**Town of Kittery
Planning Board Meeting
February 13, 2020**

ITEM 1 – 76 Dennett Road – Sidewalk/Street/Landscape Design Discussion

Re: Landscape Design Review
Response to Ironwood Design Group Review Comments
Proposed Mixed-Use Development at 76 Dennett Road
Tax Maps Lots 6-15B, 6-16A, 13-4, Kittery, Maine

**RE: Town of Kittery, Planning Board Services
Mixed-Use Development Proposal – 76 Dennett Road Lots 6-15B, 6-16A, 13-4
Final Review Comments - January 23, 2020 Submittal
CMA #591.125**

The first page of the plan is the road and sidewalk improvements, the rest are more landscaping and detail-related. If you could provide your input by Weds, Feb 5th, we would appreciate it.

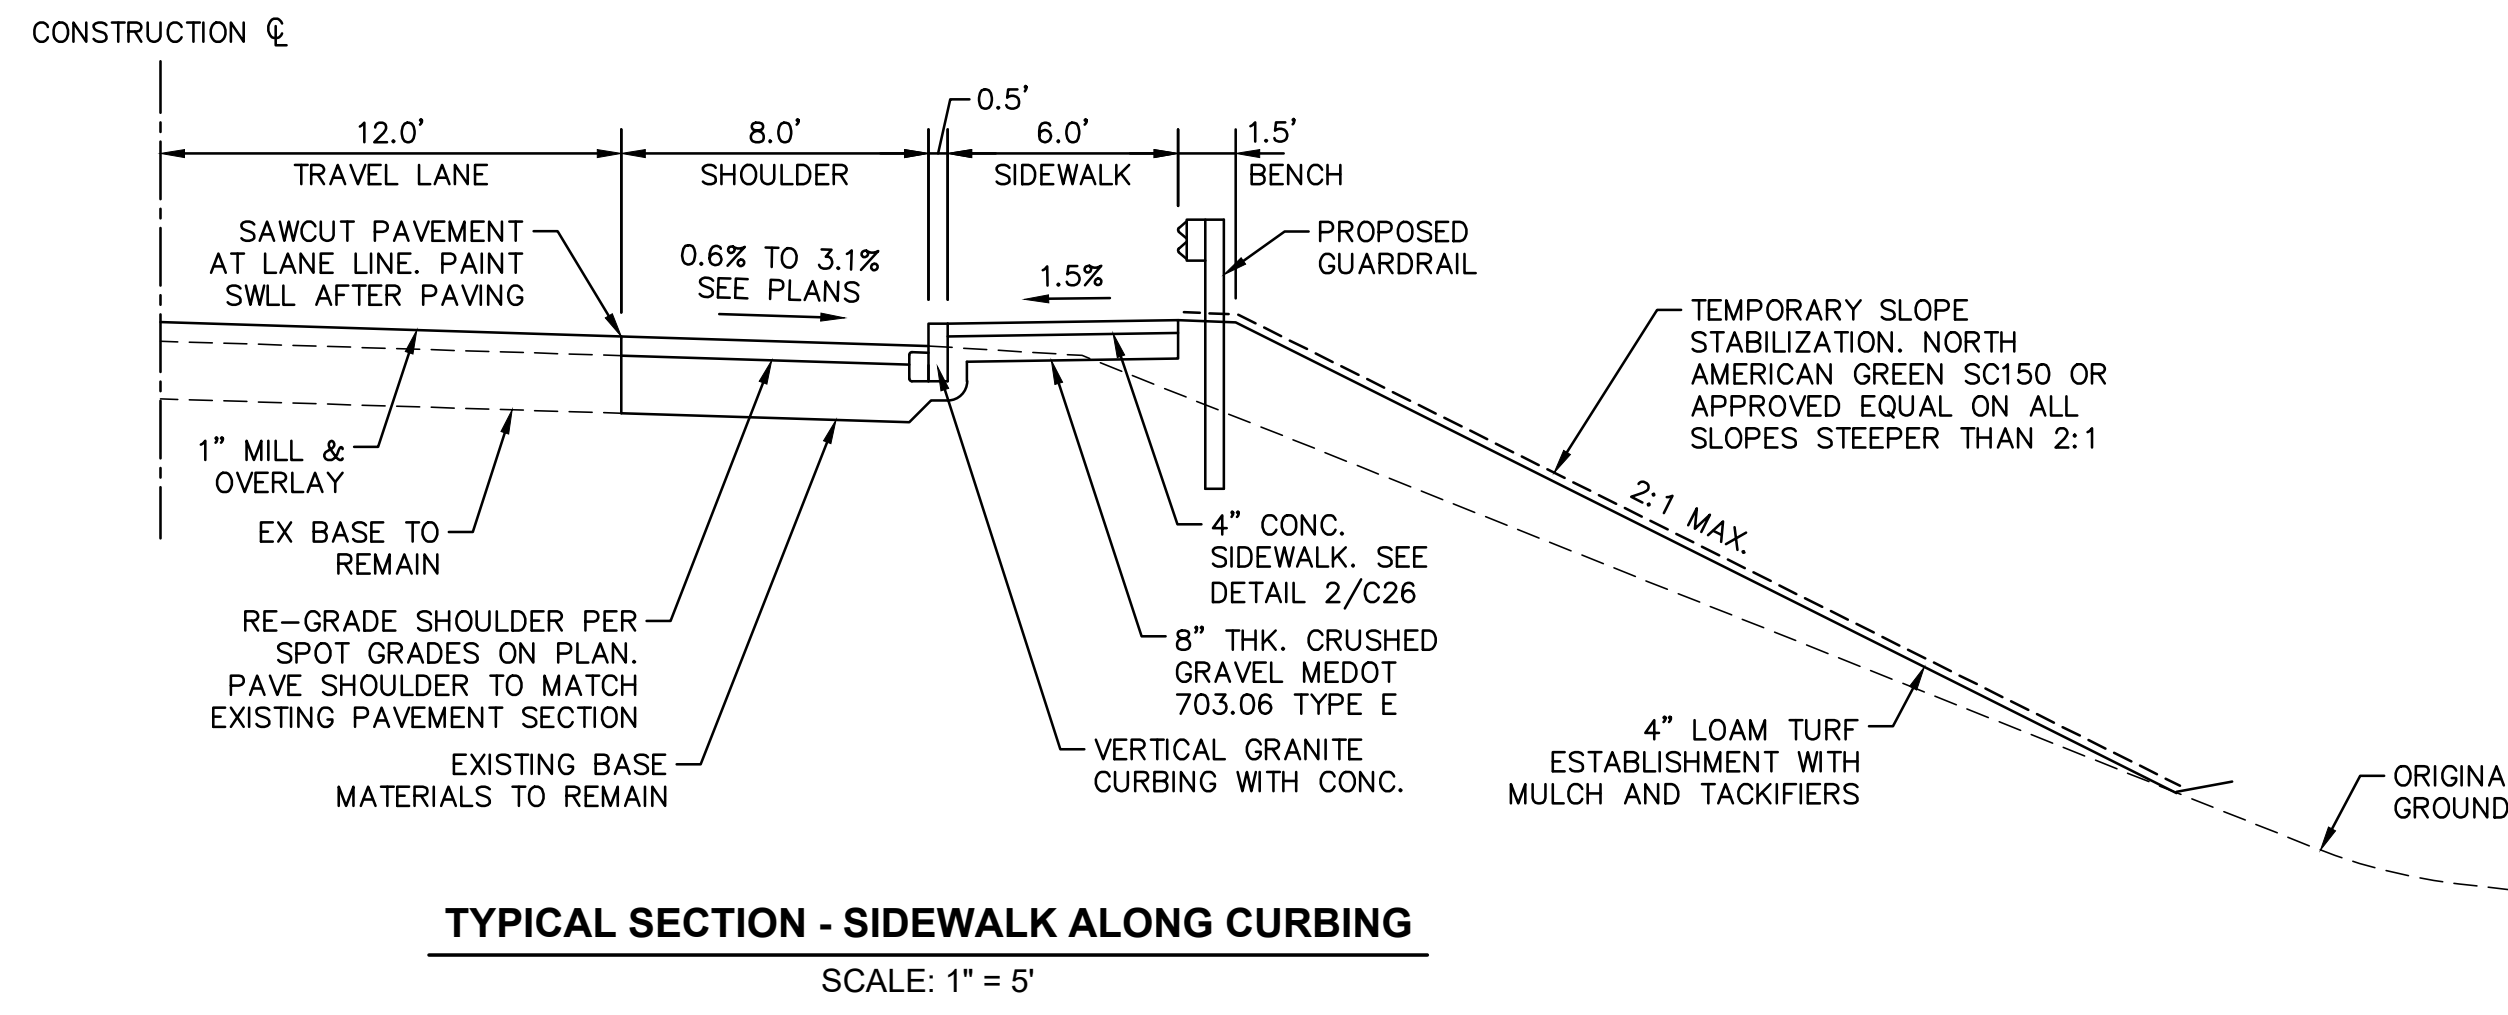
The sidewalk detail drawings don't quite align with the plan (regarding which sidewalk design segment includes the guard rail and certain shoulder widths). The plan shows there will be vegetation removal and grading involved with the sidewalk installation.

On January 9, 2020, we provided you a letter with review comments on the project's Traffic Movement Permit, including a traffic study. In addition, we commented via email dated January 16, 2020 regarding issues associated with providing sidewalks. The final revised drawing C13 (Dennett Road Improvement Plan):

- Satisfactorily incorporates our recommendations for configuration of the turning lanes and their expected functioning with respect to the traffic study, and
- Incorporates a supportable and reasonably designed and integrated sidewalk along the lot's frontage on Dennett Road.

FRONT
LANDSCAPING PLAN
C18
PROJECT NO. 569200
SHEET 18 OF 27

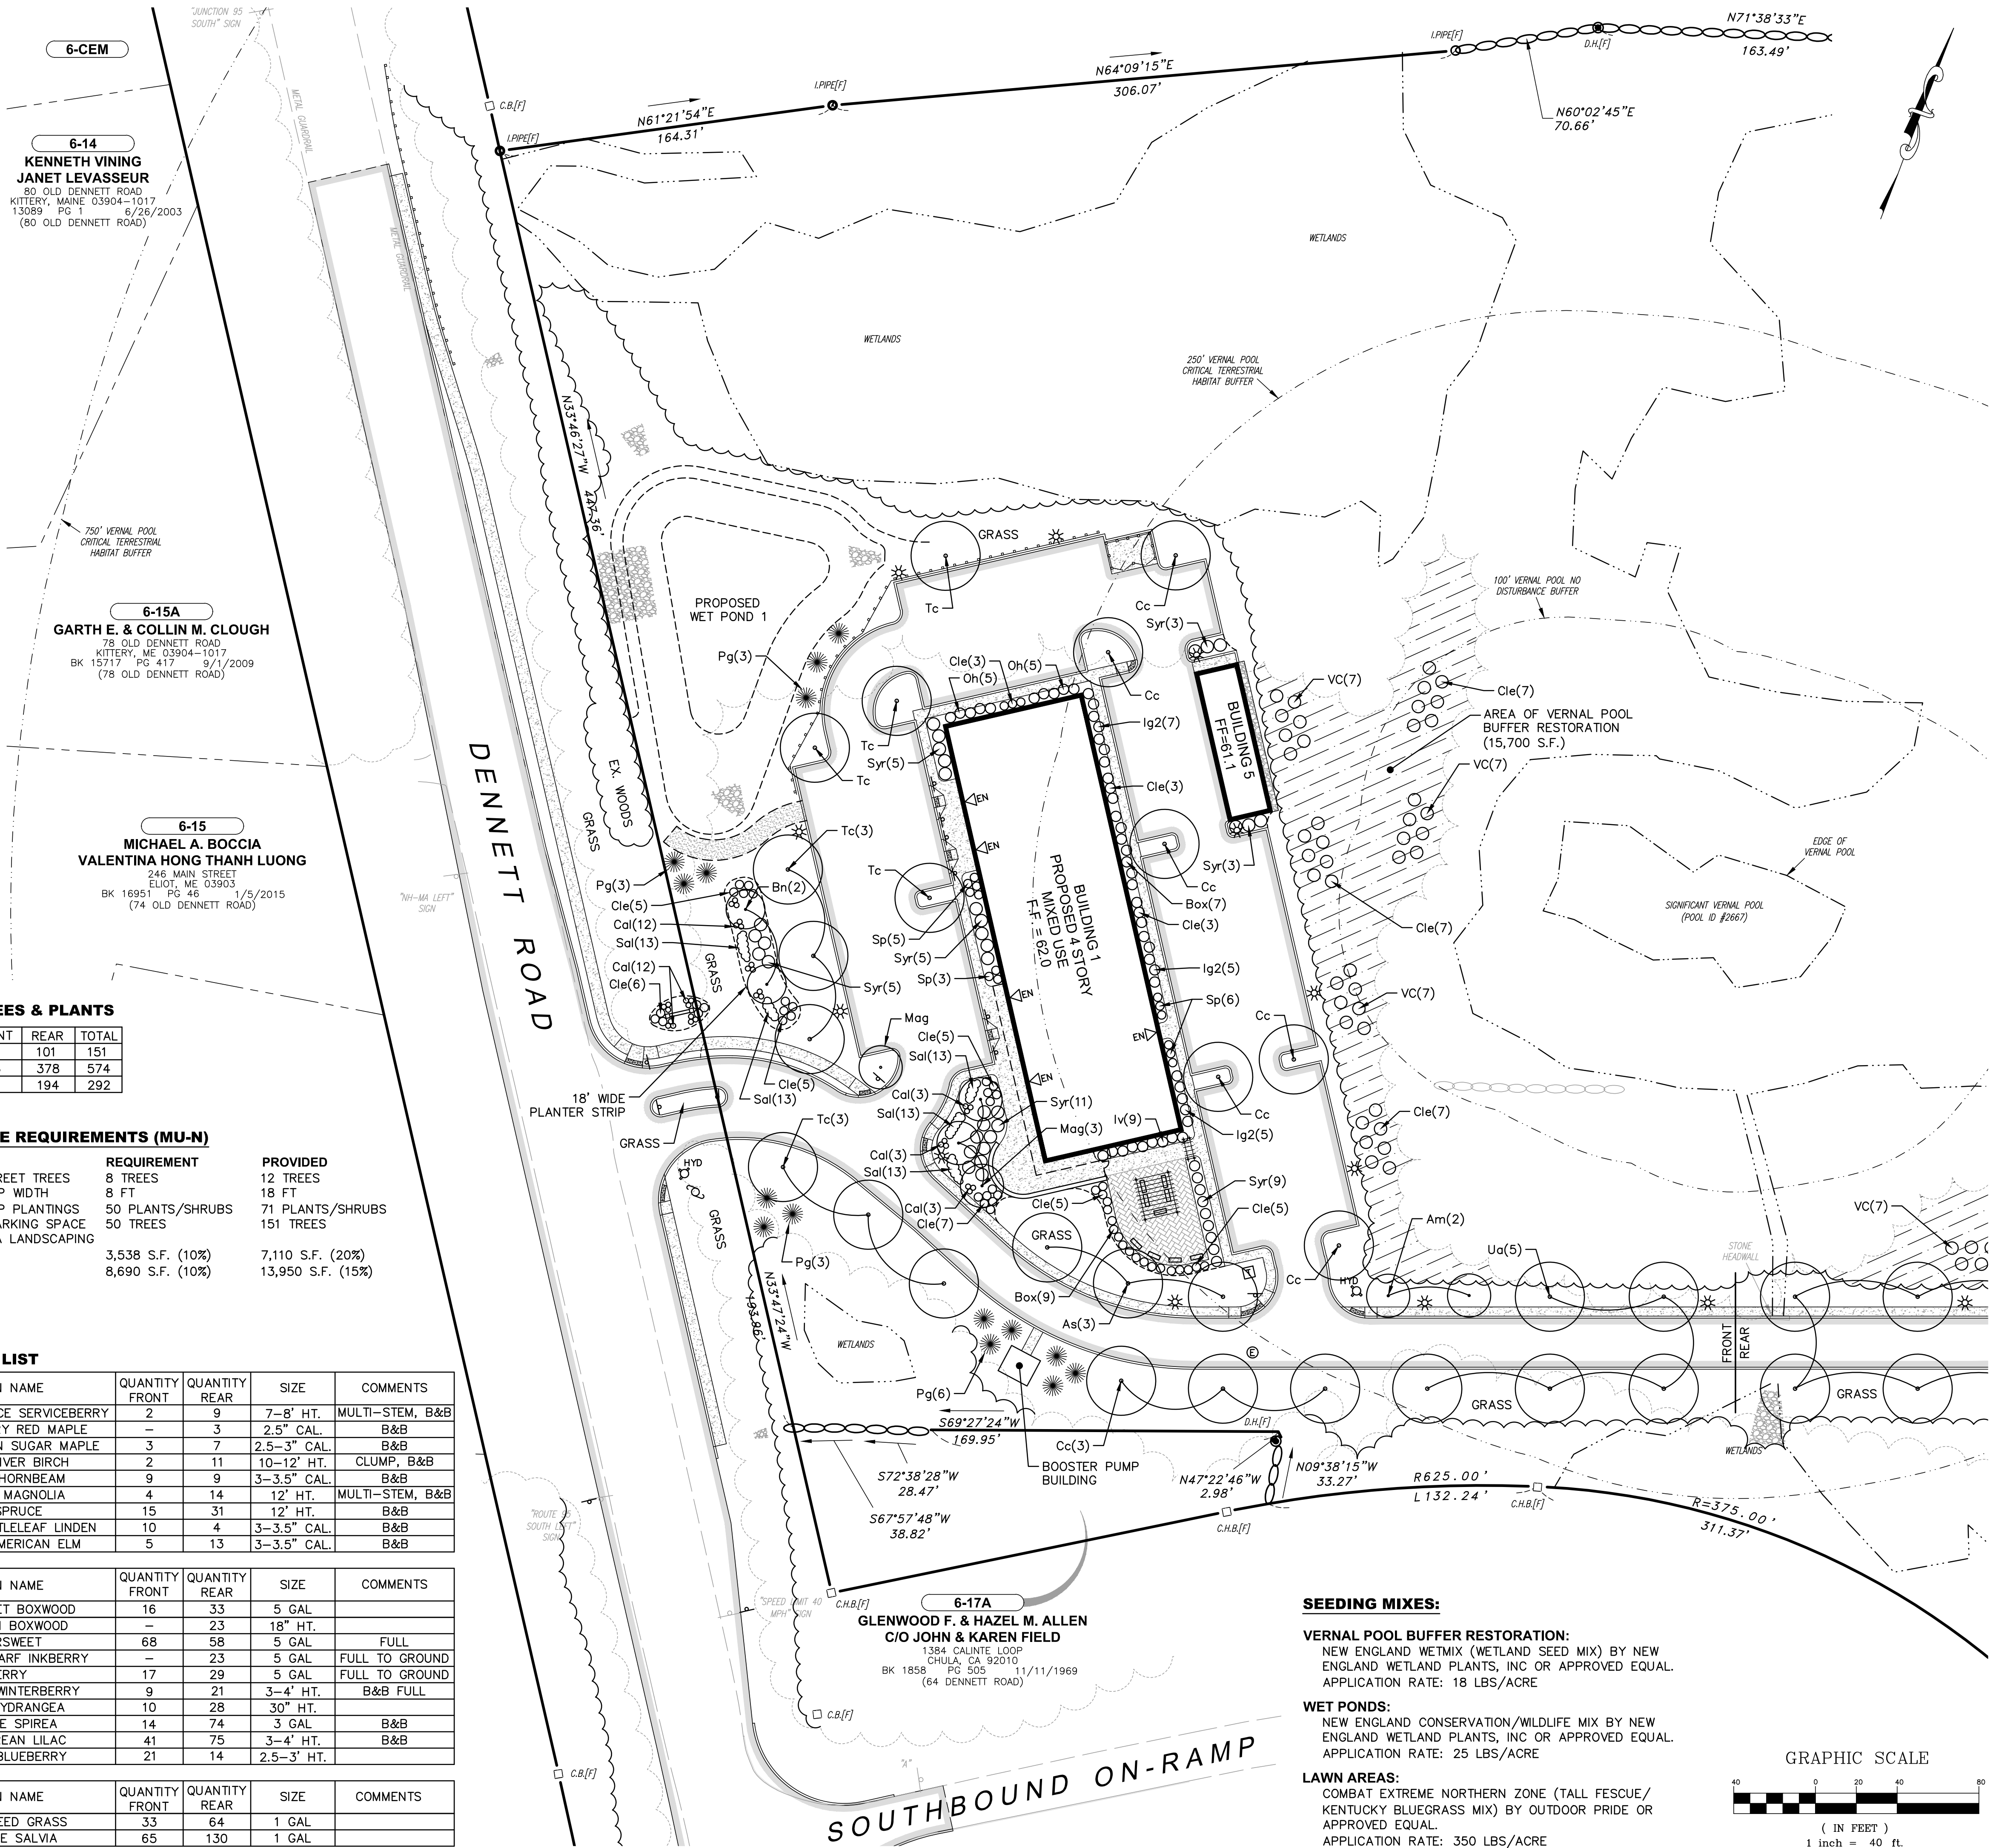
1. Clarify the soil and planting treatment for the area of vernal pool buffer restoration. Clumps of shrubs are shown but the planting for the large areas between these shrubs is unclear. If the area is to be seeded, seed mix should be specified.

2. Specify seed mix/planting plan for the proposed wet ponds.

3. Specify grass seed mix and provide grass planting detail.

7. *The parking lot screening and Building 1 does not seem adequate to meet the requirements of section § 16.8.4.12. The code calls for the screen to either consist of street trees and a fence or an 8'-wide continuous planting bed with 50% evergreen plants at 6'-high minimum.*

10. *Consider including more trees around parking lots. According to square foot calculations on the drawings, 51 trees are required, but only 37 trees are provided within the parking lot area.*

Note #13 on sheets C18 and C19 was revised to read as follows: "In the vernal pool buffer restoration areas, the contractor shall remove any fill material, replace with 4" of onsite native topsoil, plant specified shrubs and seed with the specified restoration mix. Restoration areas shall be monitored for two (2) full years to ensure vegetation is established."

A vernal pool buffer restoration seed mix was added to sheets C18 and C19.

A wet pond seed mix was added to sheets C18 and C19.

A grass seed mix was added to sheets C18 and C19

A life maintenance note (note #7) for street trees was added to sheets C18 and C19

The proposed landscaping at the front of Building 1 was revised to include a continuous raised 18' wide planter strip with additional evergreen trees.

The plans were revised to specify irrigation for planting and lawn areas as specified in notes #15 and #16 on sheets C18 and C19.

The proposed plans call for 66 trees around the proposed parking areas and total of 151 street trees onsite. The 37 trees referenced in the comment do not appear to include the trees around the parking at the front of the site as shown on sheet C18.
